2600 Don Mills Rd – Official Plan Amendment and Zoning By-law Amendment Applications – Appeal Report

Date: May 7, 2026

To: North York Community Council

Planning Application Number: 24 254890 NNY 17 OZ

Attachment 7: Official Plan Amendment 490 Street Network (Schedule 2 - The Designation of Planned but Unbuilt Roads)

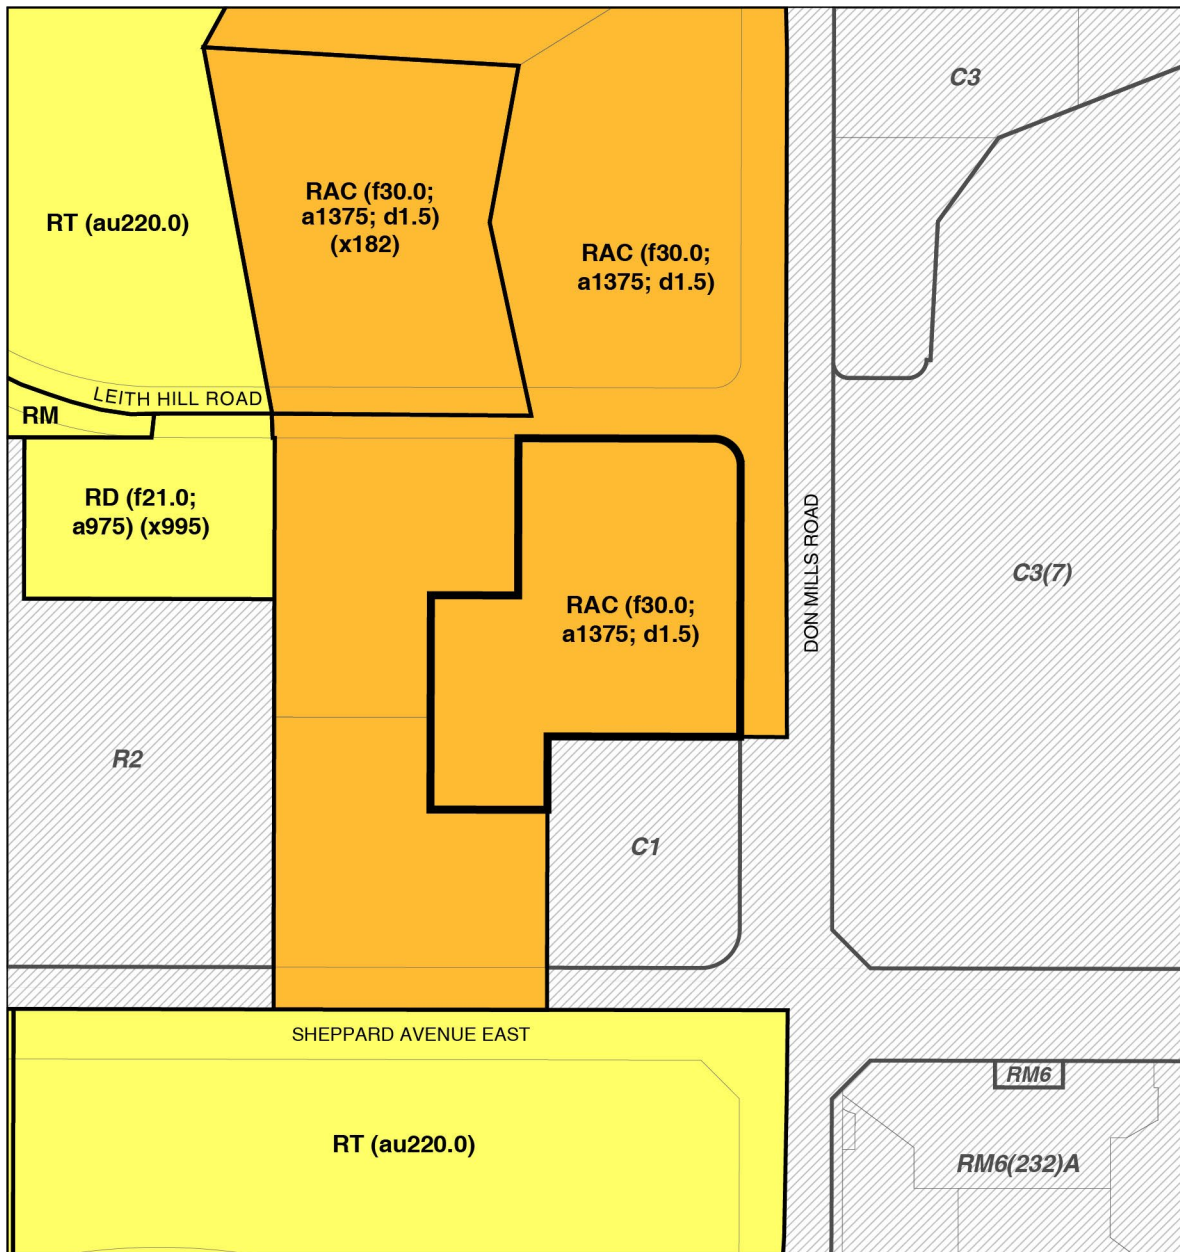
The current proposal is a deviation from the intent of the Official Plan and design guideline. Rather than a new Street C that connects to Street A and B, the current proposal provides for a midblock connection that is not coordinated with the other properties within the block and no longer provides the intended vehicular and pedestrian movements as originally envisioned. Staff do not support the deletion of the planned public Street C that is replaced by a mid-block connection. The planned public street network acts a fundamental organizing element of the Block's physical structure for the proposed multiple buildings on each site of the Block. The street network is necessary in supporting pedestrian and vehicle access, building frontage, park frontage, and coordinated and consolidated municipal servicing as directed by Official Plan. Official Plan 2.2.5 h) states that ensuring that new streets will be provided in consideration of surrounding land uses and will contribute to the development of a connected network, which provides direct and clearly understood travel routes for all transportation modes and users throughout the City.

The proposal eliminates planned public Street C. Schedule 2 identifies Street C as a north-south public street with a right-of-way width of 18.5 metres, which will include two lanes for vehicular traffic in each direction, sidewalks on both sides of the road surface, and a soft landscaped boulevard.

Official Plan Schedule 2 identifies Street A as a new north-south public street that connects to Street B. Street A is planned for a right-of-way width of 15 metres and will include two lanes for vehicular traffic in each direction and a sidewalk on the east side of the roadway. When the abutting property to the west redevelops, the additional 1.5 metres would be provided to include a public sidewalk on the west side of the road surface and a wider landscaped boulevard on lands that presently form part of St. Timothy Catholic Public School.

Attachment 9: Block Context Plan

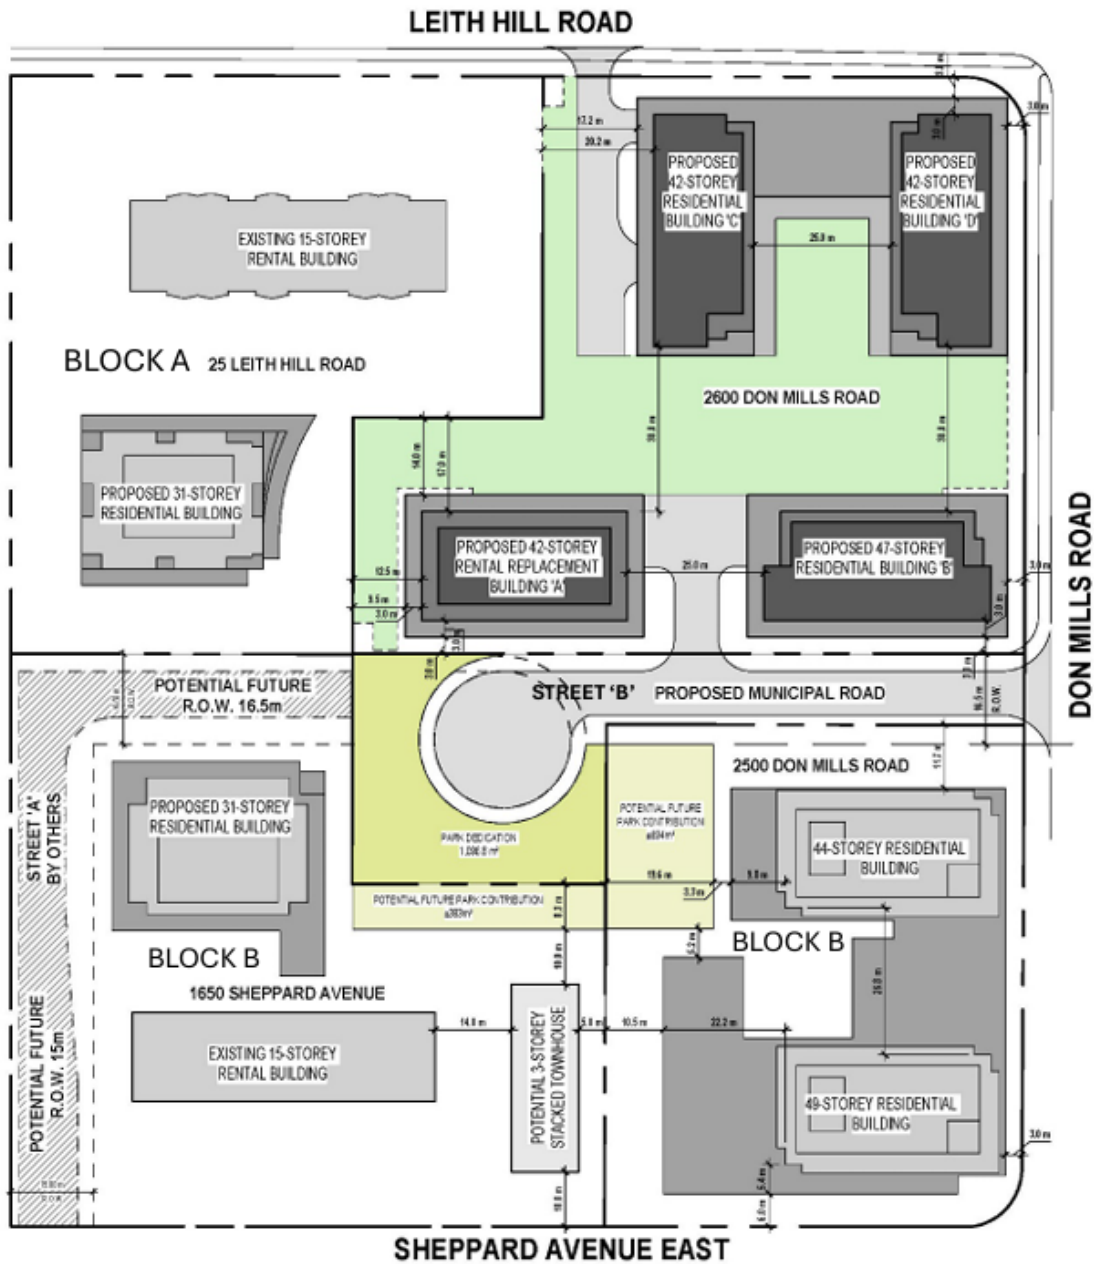
In addition, the proposed introduction of two cul-de-sacs and the removal of Street C does not improve mobility movements within the Block or within the larger transportation network. To meet current and projected needs, the City planned road network provides for increased mobility options and movement including a new signalized traffic control at Street A/Sheppard intersection that mitigate impacts on the existing transportation

The proposed Phase 1 alternative block context plan provided by the applicant introduces two cul-de-sacs and the potential deletion of planned public Street A as it references Street A as a "Potential Future R.O.W" However, the proposed relocated centralized public park proposed in Phase 1 which is reflected in the applicant's block context plan (Attachment 10) but is not reflected in the applicant's draft Official Plan (Attachment 13) proposes, in Phase 2, additional reconfiguration of the centralized public park to accommodate the connection of Street A to Street B that will eliminate the north end of the Phase 1 public park configuration, but add parkland on the south side using the area from the former cul-de-sac layout.

The proposal seeks to locate the cul-de-sac of Street B within the Block's centralized public park. The proposed park size, location, and configuration resulting from the proposed location of the cul-de-sac undermine the objectives of OPA 490 and OPA 476 and the proposed park does not meet the Official Plan's Parks and Open Spaces Policy 3.2.3.8 c), which states that the location and configuration of land to be conveyed should be of a usable shape, topography, and size that reflects its intended use.

Site Plan

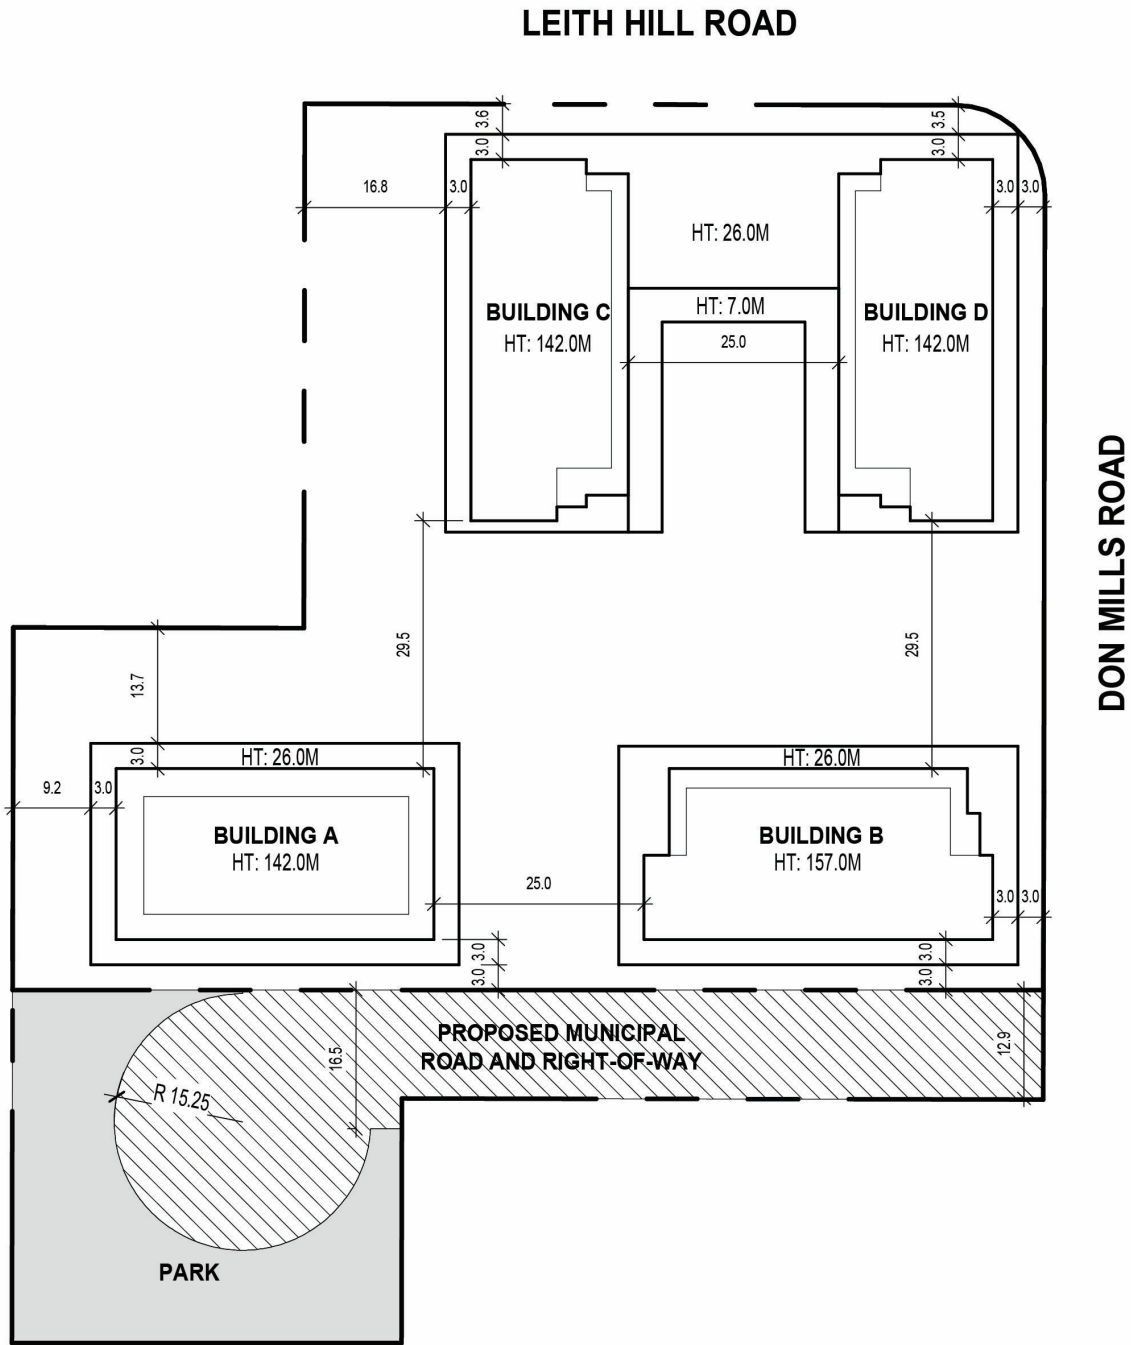
Policy 3.1.3.1e) states that development will frame and support streets by preserving existing mature trees wherever possible and incorporating them into the development site. The proposed development will remove most of the existing mature trees within the site due to insufficient setbacks and soil volumes that do not meet the objectives of the Official Plan. In addition, all proposed trees within the outdoor amenity spaces are located on the slab above the underground parking structure. The proposal should ensure the finished elevation of the underground parking structure allows for a minimum soil depth of 1.2 metres above a well-drained soil layer on top of the underground slab to support mature trees.

The SDMLHB – UD Guidelines identifies a potential POPS at the corner of Leith Hill Road and Don Mills that will reinforce the green and public realm character of the area. The proposal should be revised to incorporate a POPS or open space that supports the preservation of large mature trees and contributes to the public realm.

Official Plan Policy 3.1.3.4 f) and the SDMLHB – UD Guidelines direct development to provide active uses along the streets. Staff recommend providing at-grade active uses such as retail and service uses that add vibrancy and interest to the pedestrian environment while serving the existing and projected residents with the necessities for daily living including employment. Currently, private indoor amenity space is proposed on the Leith Hill Road frontage.
